ADDENDUM NO. 3

March 19, 2010

PROJECT: REDEVELOPMENT AGENCY FOR THE COUNTY OF RIVERSIDE
PERRIS VALLEY – BIG LEAGUE DREAMSMIG, INC.
801 N. HARBOR BLVD
FULLERTON, CA 92832

ADDENDUM #3
SD SHEET C3.1-REVISED BIOCLEAN
BAFFLE BOX SIZE
DATE 3-17-10
SHEET 1 OF 2

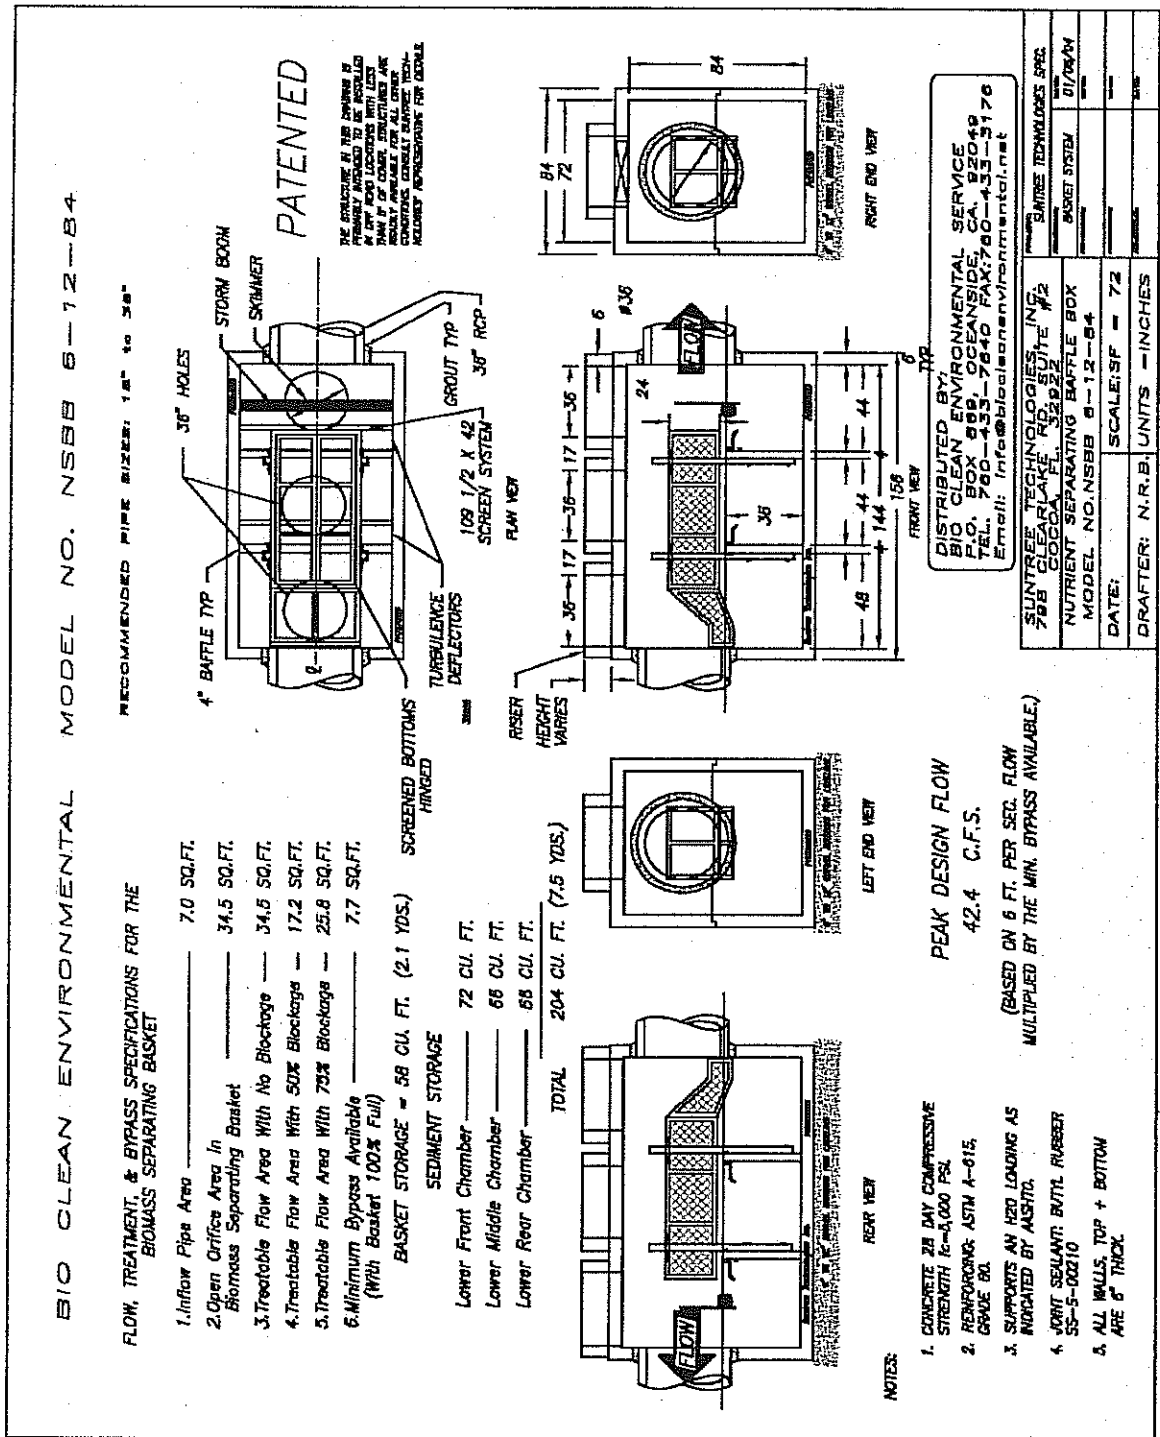
Proposed Bioclean Baffle Box unit shown on Civil Sheet C3.1 note #22a has been revised to reflect the applicable size needed for this project. Attached is revised drawings C3.1 and detail drawings C3.01 for reference.

22a CONSTRUCT BAFFLE BOX MODEL NO. NSBB 6-12-B4 BY BIOCLEAN PER DETAIL #22a ON SHEET #2 OF 2 (OR APPROVED EQUAL). CONTRACTOR TO COORDINATE WITH MANUFACTURER.
